**FINAL ENVIRONMENTAL IMPACT STATEMENT
(FEIS)
VILLAGE VIEW CLUSTER SUBDIVISION
VILLAGE OF WARWICK, ORANGE COUNTY, NEW YORK**

Project Name: Village View Cluster Subdivision

DATE OF SUBMISSION January 28, 2020

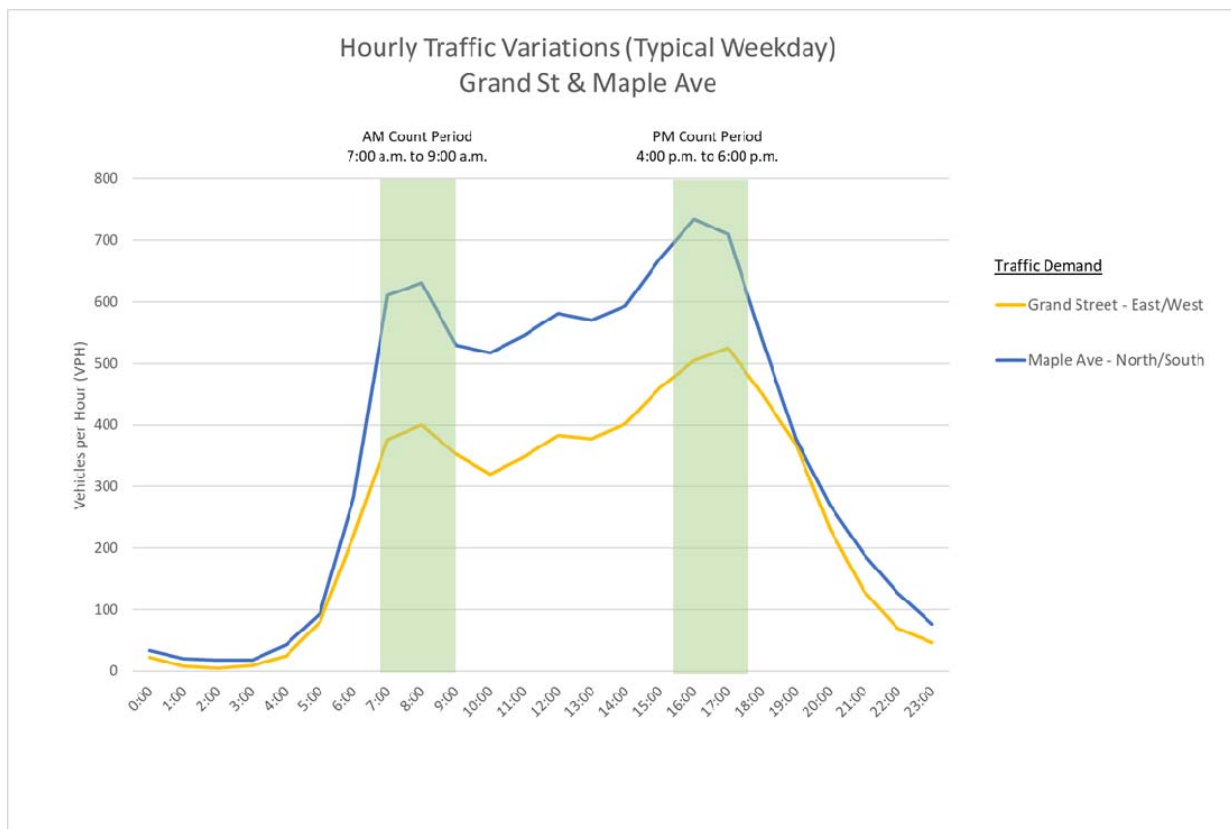
SEIS Comment G.1.37: *Intermunicipal Impacts of both this and future projects; Overall, it would be prudent to determine the combined impacts of this project along with the impacts of the future 25-lot cluster in the Town of Warwick. This is particularly important with respect to traffic impact, as well as the design of the future cluster subdivision in the Town of Warwick in relation to the Village View Cluster alternative. The importance is how both projects relate to each other and preexisting development in both the Village and Town of Warwick. (OCPD-4)*

SEIS Response G.1.37: We concur that inter-municipal impacts of both projects should be considered. The traffic impact study dated June 21, 2019 and excerpted in the SEIS, included traffic volumes associated with the previously approved 16-unit subdivision (Zadeh Drive) in the traffic projections and assumed the construction of the 25-lot subdivision in the Town with the completion of the Village development. The findings concluded that the cumulative increases in traffic would have not significant impacts to the transportation system.
